## SUNDRY NOTICES AND REPORTS ON WELLS

Mobil Apache #3

## **P&A Procedure**

**CONDITIONS OF APPROVAL**

#### Proposed P&A

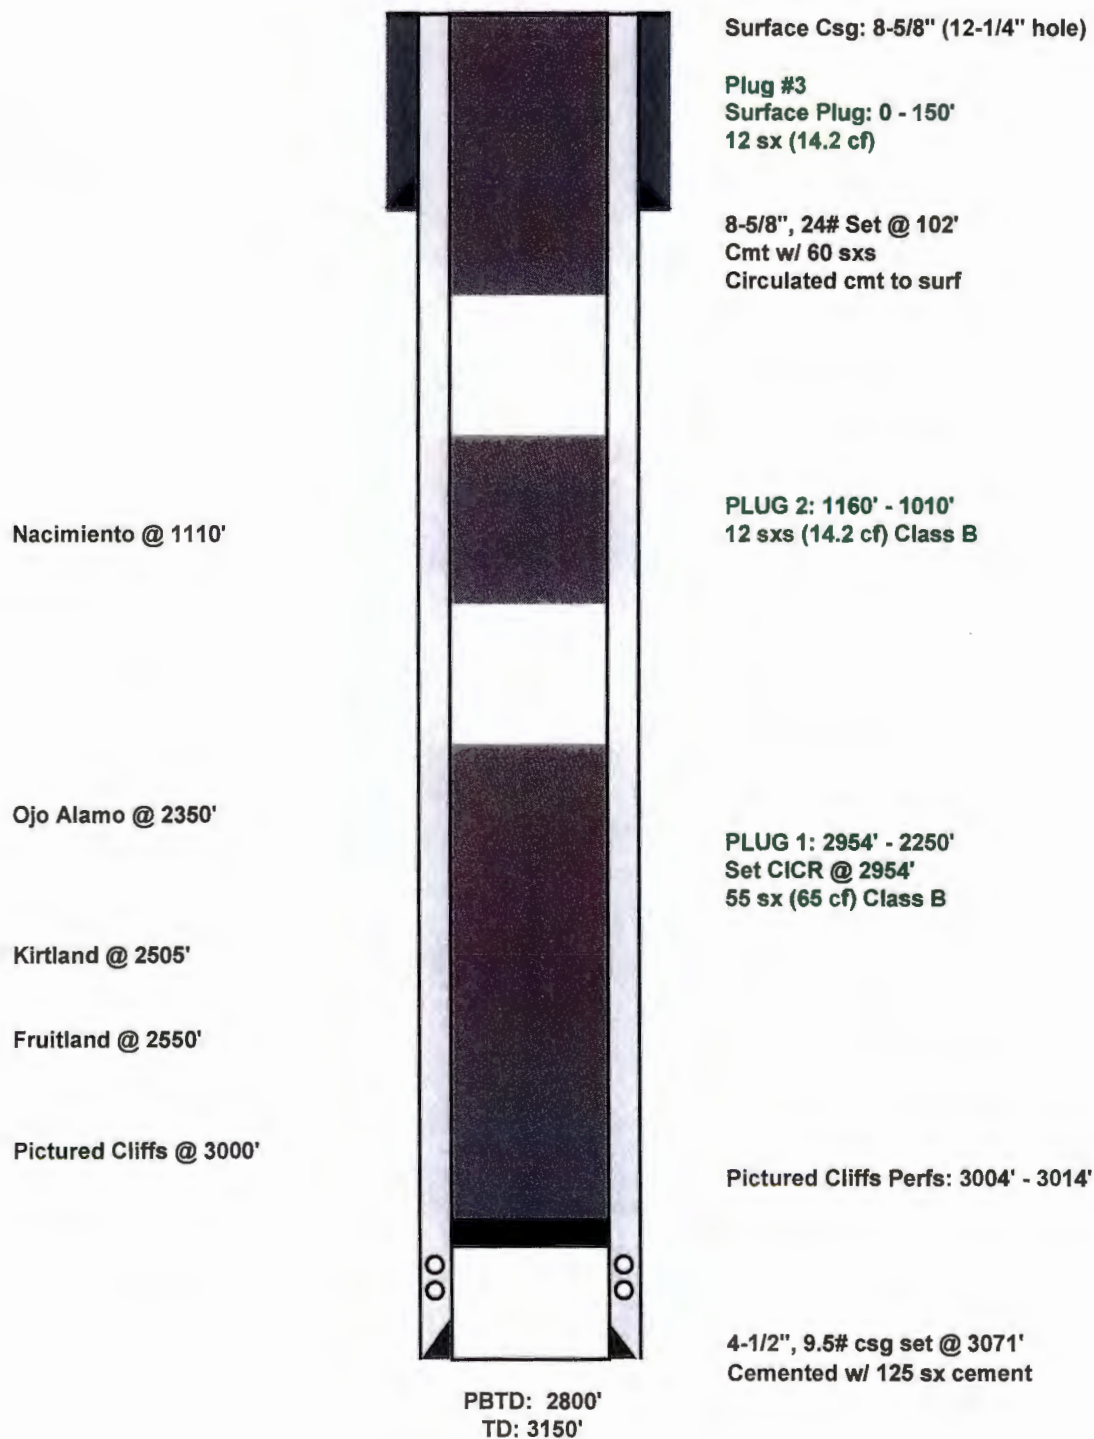
I: Set plug #2 (1520-1420 ft.) to cover the top of the Nacimiento top. BLM picks top of Nacimiento @ 1468 ft. Adjust cement volume accordingly.

BLM has no record for TOC behind 4.5" production casing. Therefore, CBL is required to be ran from CICR AT 2954 ft. to surface to verify cement top.
